# Technical Service Information

## NISSAN RE4R01A / RE4F02A SOFT OR FLARED UPSHIFTS

Figure 1

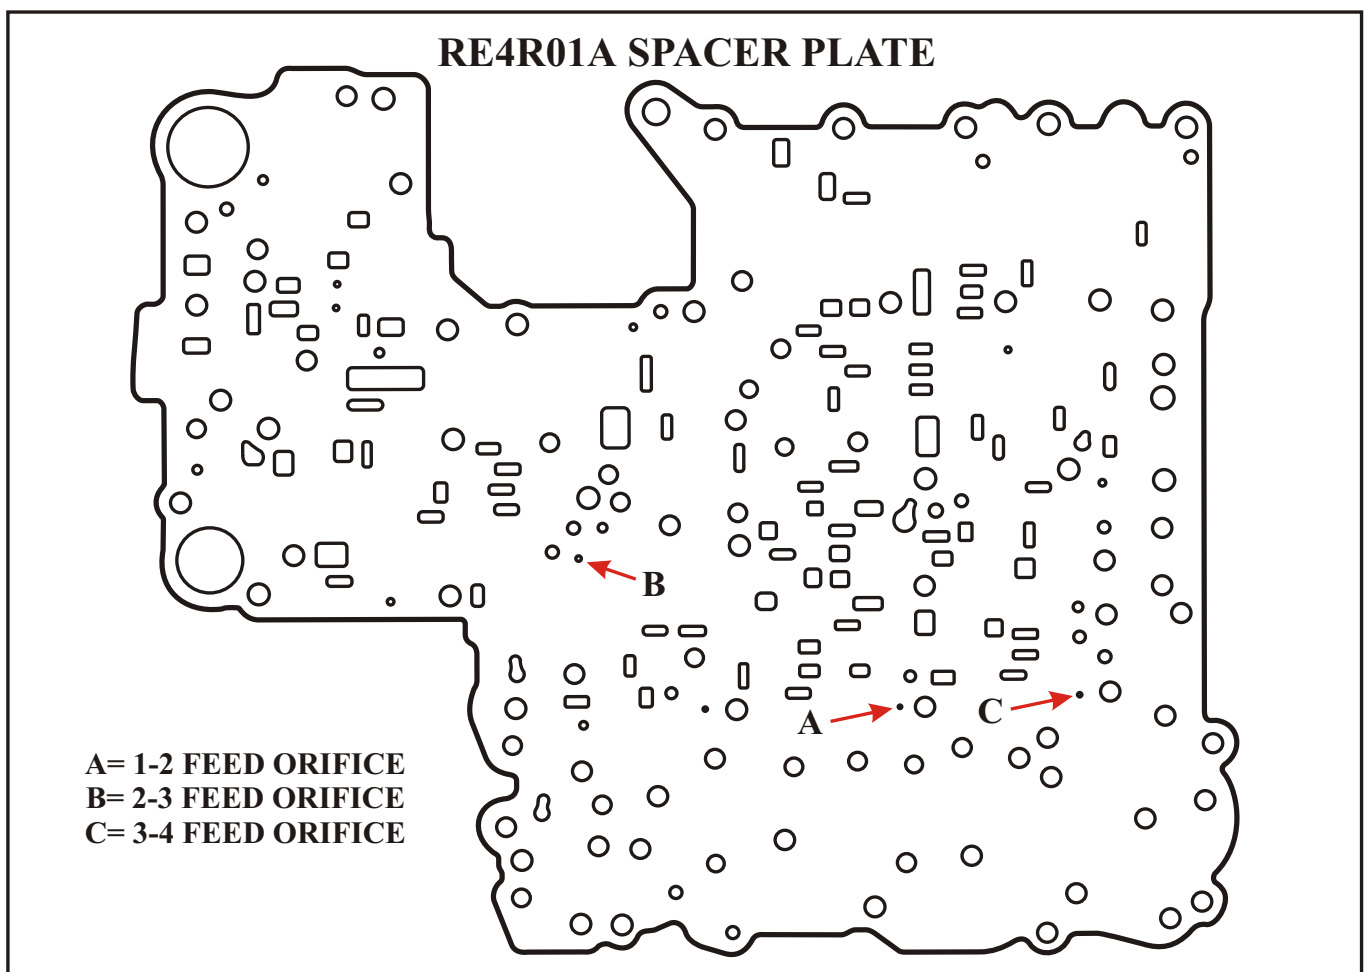
**COMPLAINT:** After overhaul, vehicles equipped with RE4R01A or RE4F02A transmissions, may exhibit soft or flared upshifts.

**CAUSE:** The cause may be, insufficient feed oil to the clutch or band servo related to the upshift taking place.

**CORRECTION:** Refer to Figure 1 for RE4R01A feed orifice locations. Refer to Figure 2 for RE4F02A feed orifice locations. To firm the upshift in question, enlarge the orifice marked in the spacer plate .020“- .030” larger.

Figure 2

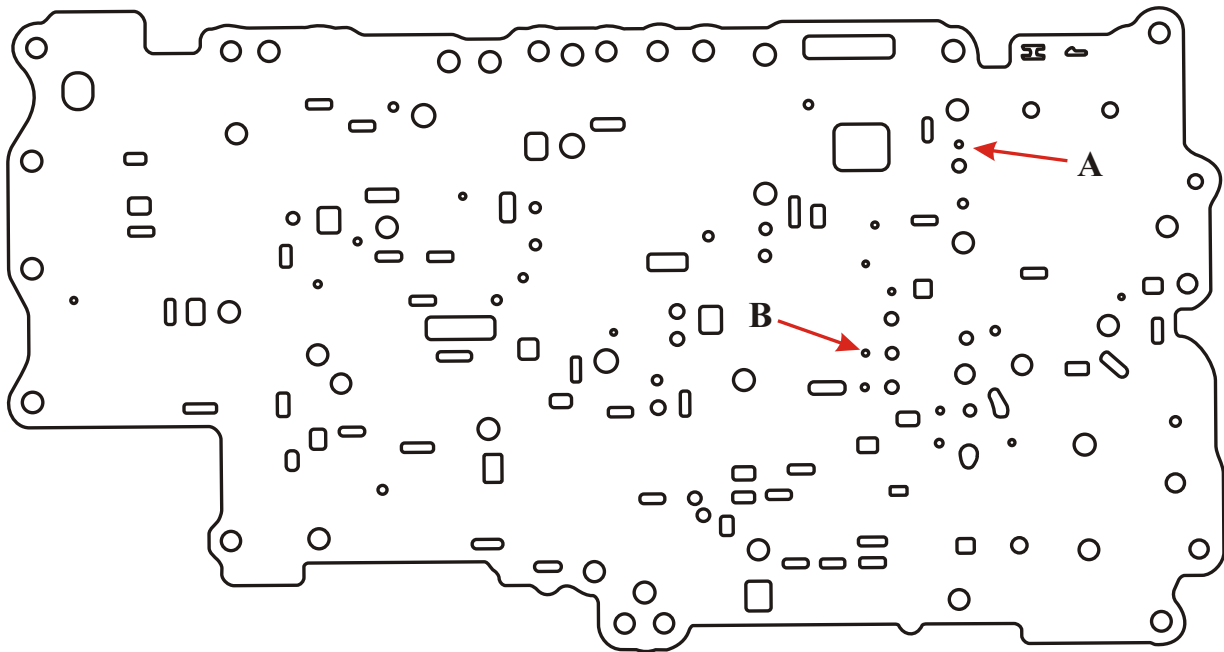
**A= 1-2 AND 3-4 FEED ORIFICE**  
**B= 2-3 FEED ORIFICE**
